# Watermark Coal Project: - EIS and Response to Submissions

Merit Review of Surface Water Issues

March 2014

**Figure 2.1:**  
**Final Landform, Rehabilitation Zones and Predicted Seepage Zones Post Mining**  
 Source: *Response to Submissions*, Figure 22

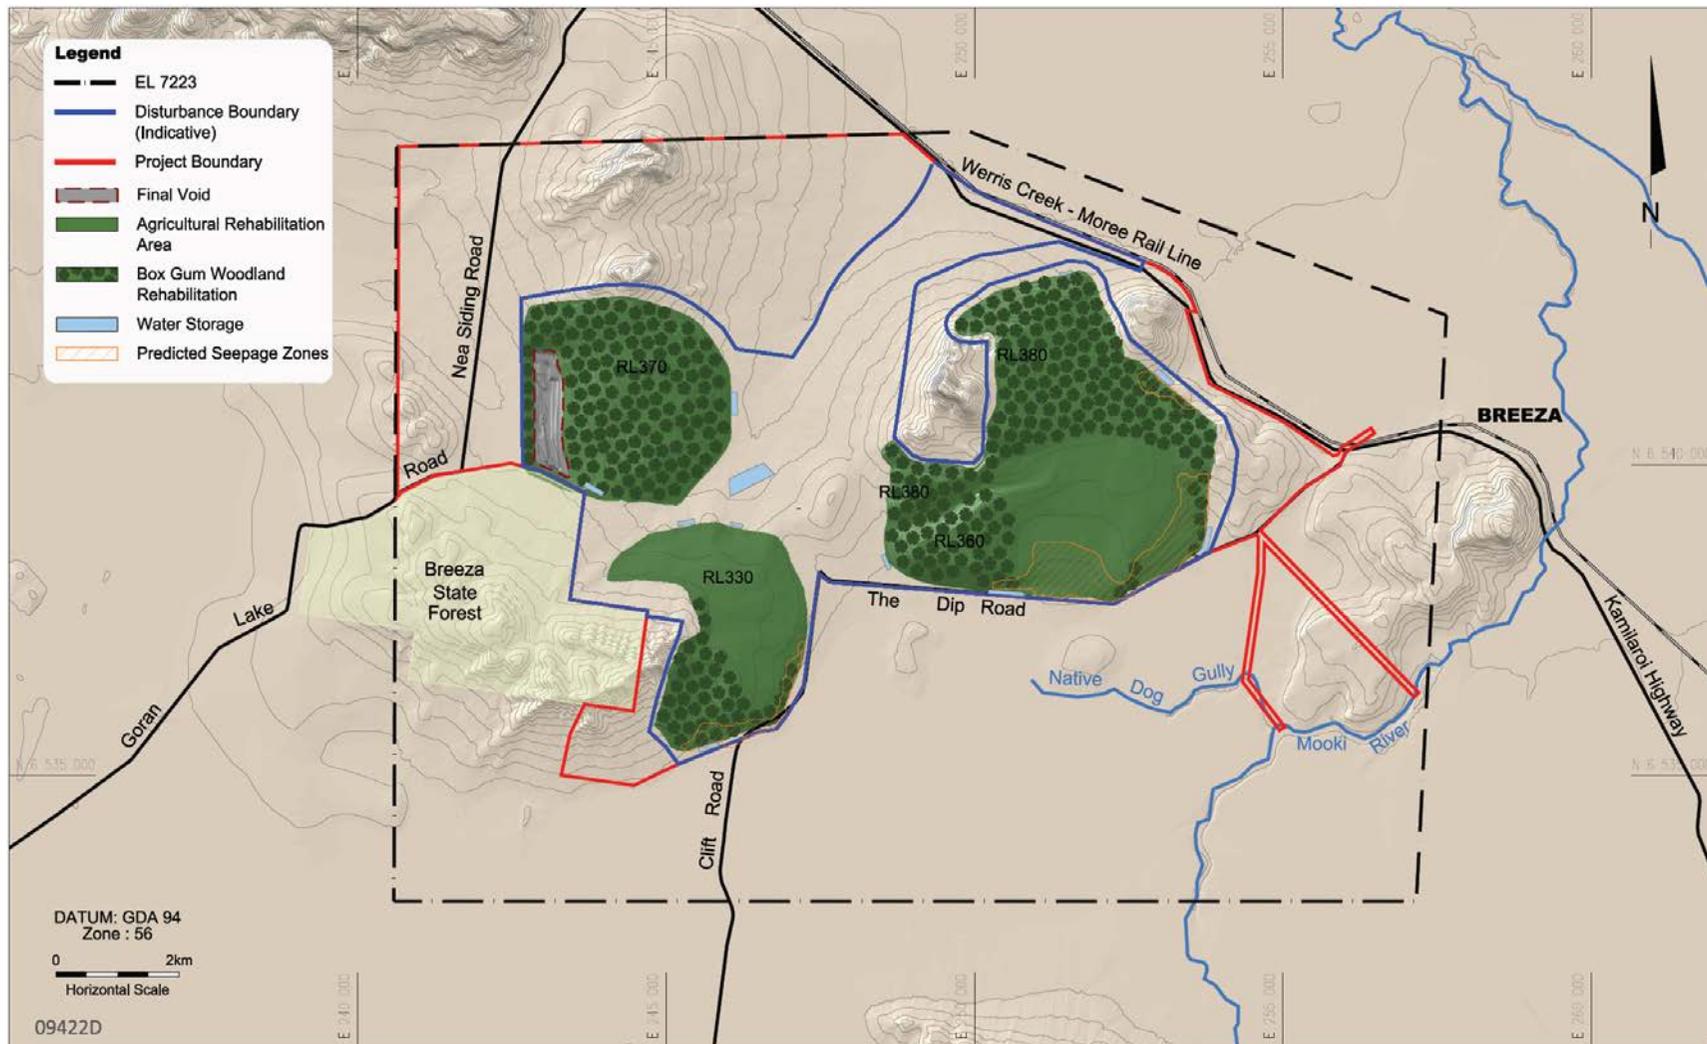
It should be noted that the *Seepage Water Quality Assessment* (Terrenus, 2013 – Appendix 6 to the *Groundwater Impact Assessment*) quotes estimated salt loads from the Eastern Mining Area of 164 t/year, or about 2 kg/ha/year. The *Seepage Water Quality Assessment* also points out that seepage is not expected to occur until about 30 years after completion of mining. Any efforts to further mitigate potential impacts would, therefore, need to rely on measures to limit groundwater recharge into the overburden emplacements such as geometry, surface soils and vegetation embedded into the final landform, rather than any direct management action at the time that seepage became apparent.

The analysis presented in the *Groundwater Impact Assessment* and its various appendices indicates that any groundwater seepage in the areas identified in **Figure 2.1** is likely to occur once the groundwater levels in the overburden have risen above pre-development levels about 30 years after completion of mining.

- In the event that long term seepage cannot be prevented by actions taken during the rehabilitation process, development of a robust post mining vegetation management plan for

the predicted areas of saline seepage with a view to planting of salt tolerant vegetation in areas where seepage is predicted (using the same principle as has been successfully employed to combat dry-land salinity elsewhere in the Mooki River catchment).

**Figure 4.1: Conceptual Water Management System**  
(Source: EIS, Figure 34)

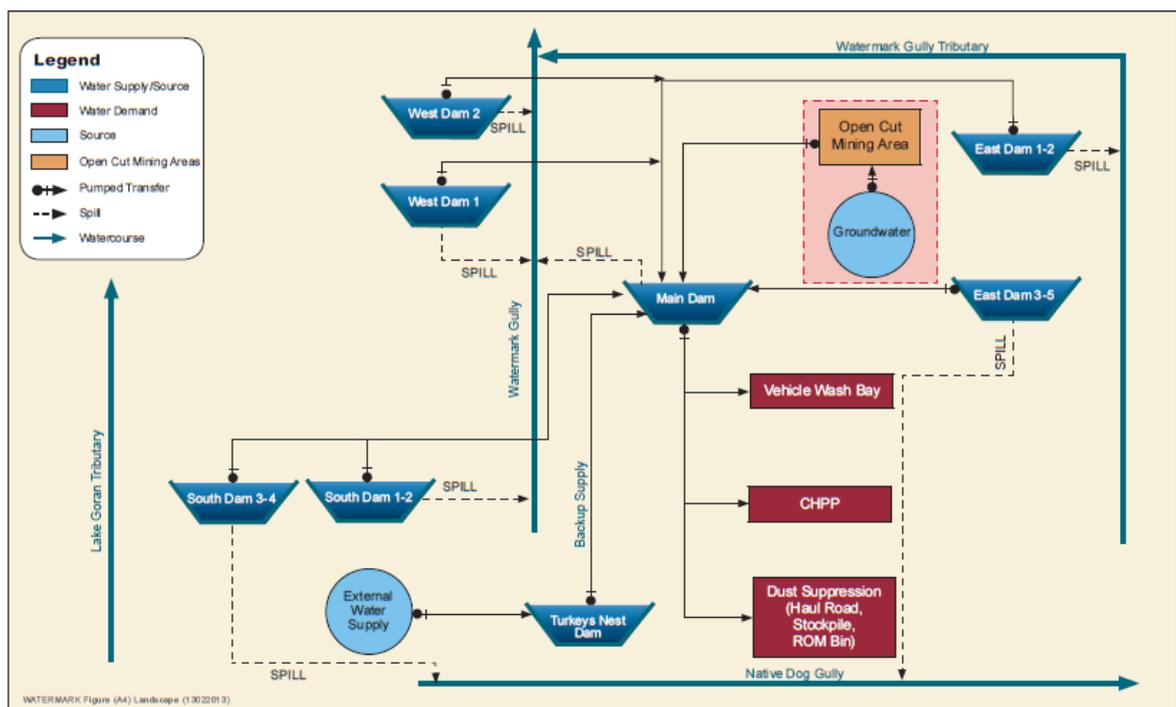
Figure 34 in the *EIS* (copied as **Figure 4.1** below) is a highly schematic diagram of the conceptual water management system for the project. The adopted colour coding and the inclusion of a link showing 'spill' from the Main Dam has led to some confusion about the proposed operation of the water management system and the possibility of some mine water being discharged to the environment. This forms the basis of a number of submissions. Three aspects of the figure should be noted (and are clarified in the *RTS*):

- East Dam 1-2, East Dam 3-5, South Dam 1-2, South Dam 3-4, West Dam 1 and West Dam 2 represent the sediment dams that would receive runoff from the overburden emplacements. The schematic diagram shows water being pumped from these dams to the Main Dam from which water is drawn for mine operating purposes (solid line in the figure). This route for water represents water that is pumped to the Main Dam because water is required to supplement mine water supply from other sources or because it does not meet water quality criteria for discharge to the environment. A second (dotted line) from these dams is simply labelled "spill". This label does not accurately reflect the intended operation of sediment dams which are intended to capture and retain runoff from the nominated 'design' storm. The retention volume of the sediment dam is then to be restored within 5 days of the end of

the rainfall period that led to runoff. Restoration of the retention volume may be achieved either by controlled release from the dam to the environment (subject to complying with water quality criteria) or directed to the mine water management system. Any discharge from the sediment dams in this manner should more correctly be referred to as a 'controlled release' rather than 'spill'. 'Spill' may however occur in circumstances where a storm leads to a larger volume of runoff than that from the nominated 'design' storm. However, as indicated in Table 6.2 of *Managing Urban Stormwater: Soils and Construction – Volume 2E: Mines and Quarries* (DECC, 2006) on average basins designed and operated in accordance with the requirements for a 90<sup>th</sup> percentile storm can be expected to experience uncontrolled overflow (i.e. 'spill') 2-4 events per year.

- The Main Dam will receive runoff and groundwater seepage from the mine operating area as well as water transferred from the sediment dams and backup supply from external sources via the Turkeys Nest Dam. **Figure 4.1** shows a dashed line labelled 'spill' running from the Main Dam to Watermark Gully. It is clear from the *RTS* that this line does not represent the intended operation of the Main Dam. In the event of there being any excess water that cannot be held in the Main Dam, water will be retained in one of the pits.

Despite some confusion caused by a dashed line showing “spill” from the Main Dam in Figure 34 of the *EIS* (reproduced as **Figure 4.1** above), it is clear from the text and the modelling results in the *EIS* and the *RTS* that the mine water management system (containing water exposed to coal) is intended to have no off-site discharge. Any water that cannot be accommodated in the Main Dam will be held in a mine pit until such time as it can be re-used.

To avoid some of the confusion about the intended manner of operation of the mine water management system arising from Figure 34 of the *EIS*, the figure would have benefitted from colour coding and labelling in to clearly differentiate:

It is clear from the text and the modelling results in the *EIS* and the *RTS* that the mine water management system (containing water exposed to coal) is intended to have no off-site discharge. Any water that cannot be accommodated in the Main Dam would be held in the mine pit until such time as it can be reused. A condition of approval reflecting this would be appropriate.

**Figure 4.2: Indicative Dust Suppression Water Requirements**  
(based on Thompson & Visser, 2002)

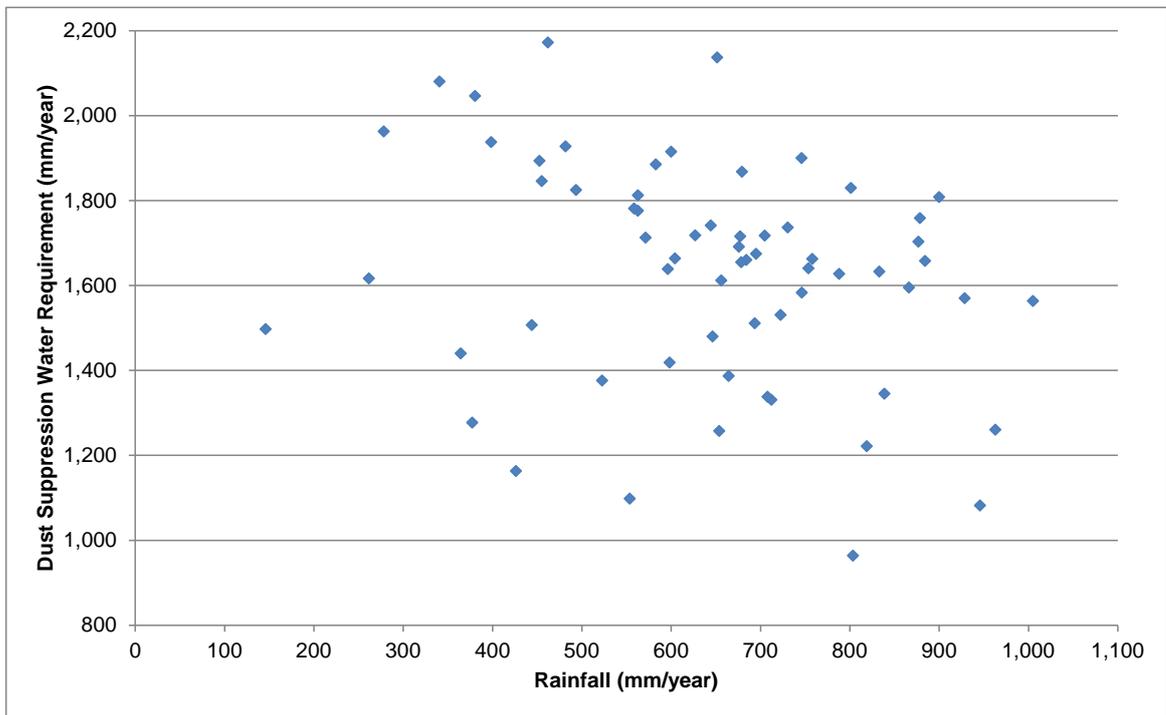
The main aspect of this indicative analysis is that it illustrates the fact that, by accounting for hot dry days when more than 4 mm of water is likely to be required, the average annual requirement (1,632 mm) is likely to be about 30% greater than actually allowed for in the water balance modelling. Although water for dust suppression only accounts for 12% of the water balance over the life of the project (after taking account of the use of chemical suppressants for about the first 20 years of the project), the under-estimation of water requirements for dust suppression is likely to place additional demand on water from external sources.

**Figure 4.3:**  
**Net Groundwater Take from Porous Rock Groundwater Zones**

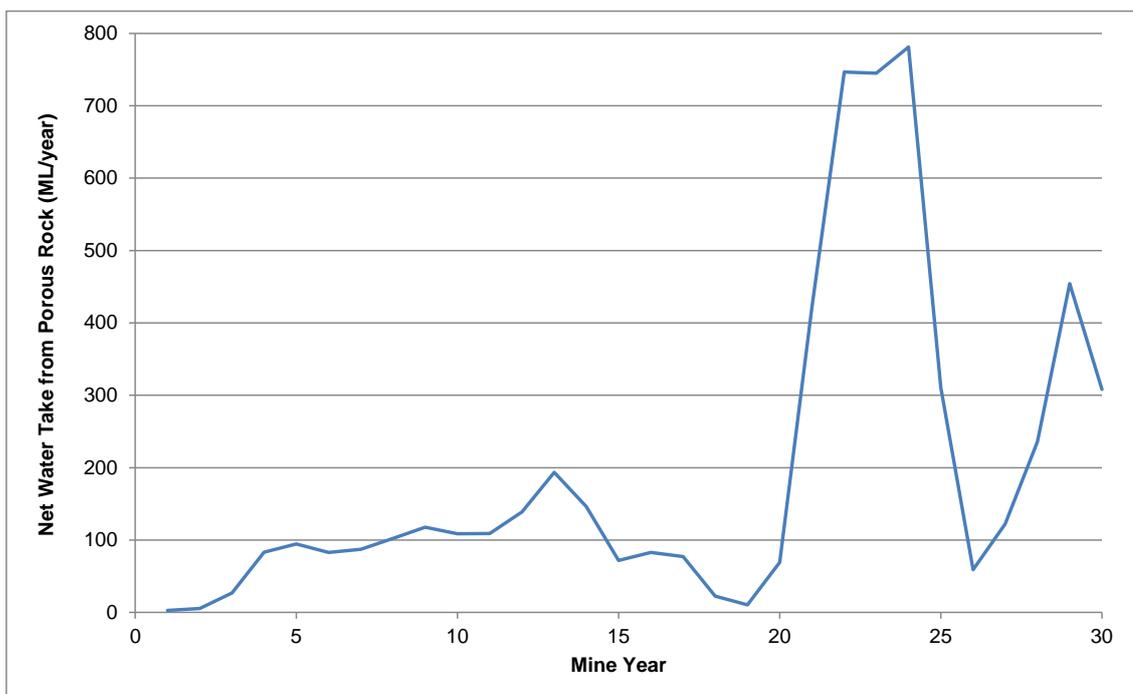
The main features of note in **Figure 4.3** are that the net water ‘take’ from the porous rock aquifers show three distinct time periods corresponding to mining in the three mine areas:

Table 7.10 of the *Surface Water Impact Assessment* lists the pumpable groundwater inflows for selected mine years. **Table 4.3** compares the data from this table with the data from which **Figure 4.3** was derived for the mine years selected for the water balance analysis. Apart from start-up years and Year 25 (which is anomalous) the data shows that for the majority of the mine operating period, the mine expects to be able to pump 40% - 60% of the seepage water that leaves the hard rock aquifers.

**Figure 4.5:**  
**Forecast Yearly Raw Water Demand**  
 Source: Surface Water Impact Assessment, Figure 7.9

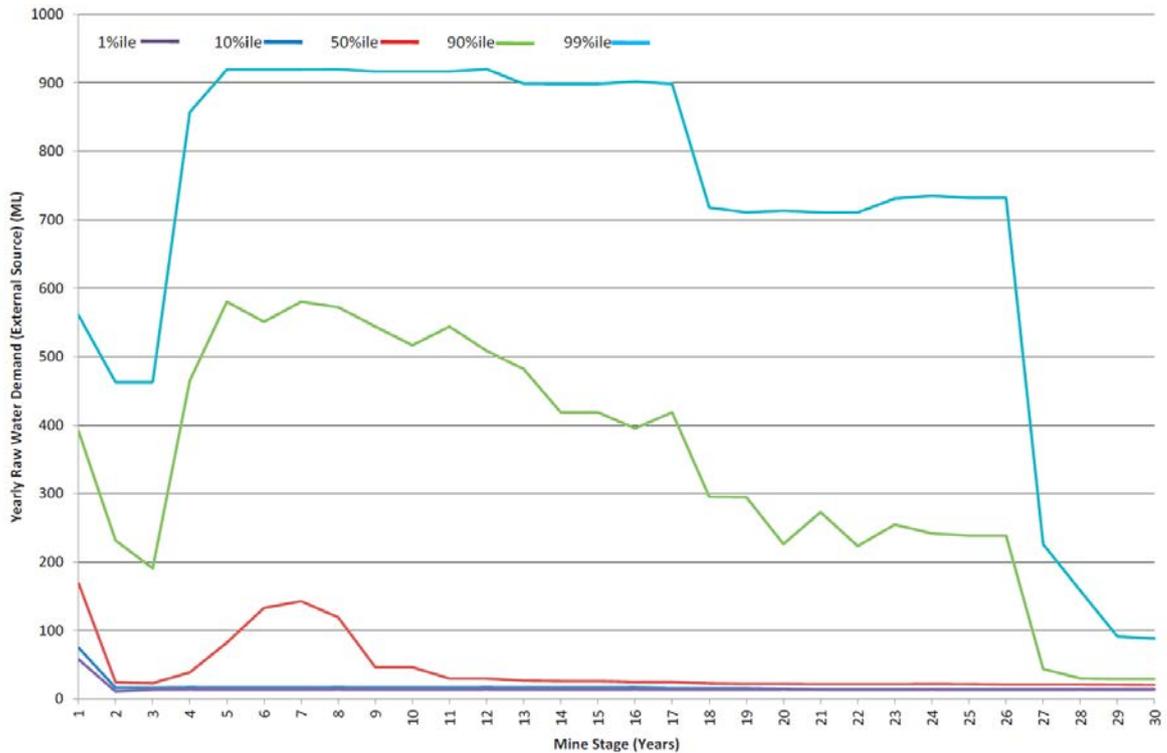
The water balance analysis in the *Surface Water Impact Assessment* demonstrates that external sources of supply will be required on occasions to maintain operations. Figure 7.9 in the *Surface Water Impact Assessment* indicates that there is a 90% probability that the external demand will be less than about 600 ML/year. This review concludes that the requirements for CHPP operation and dust suppression have probably been underestimated, although the magnitude of the underestimation is difficult to quantify precisely. Notwithstanding, the *RTS* notes that:

- As part of the preparation of a *Water Management Plan*:
  - Re-assess the sensitivity of the site water balance to conservative assumptions about the various water demands;

- Propose realistic mitigation options that could be undertaken to further reduce water demand in the event of water stress;
  - Revise the anticipated demand for external water supply;
